# PRODUCT CHANGE NOTIFICATION

Ref Nr: PCN-20211022001

**HEREWITH YOU ARE INFORMED OF OUR INTENTION TO CHANGE YAGEO BRANDING TO KEMET**

**After (YAGEO identification)**

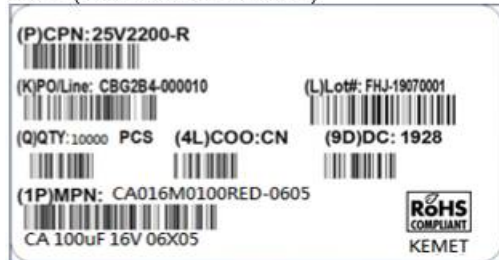
YAGEO Corp. hereby announce that E-Cap Branding will change from YAGEO to KEMET.

- A 1 year phase in is defined. The PCN effective date is 2022/01/01 and all affected part numbers must be changed to the KEMET PN by 2023/01/01.
- In the interim, customers may order either the YAGEO or KEMET PN.
- If ordering with the YAGEO PN, product through the effective date will be received with YAGEO identification (KEMET logo). After the effective date, product will be identified with KEMET identification.
- There is no change to the manufacturing location, processes, materials, equipment and personnel (anything that could affect fit, form and function of the product).
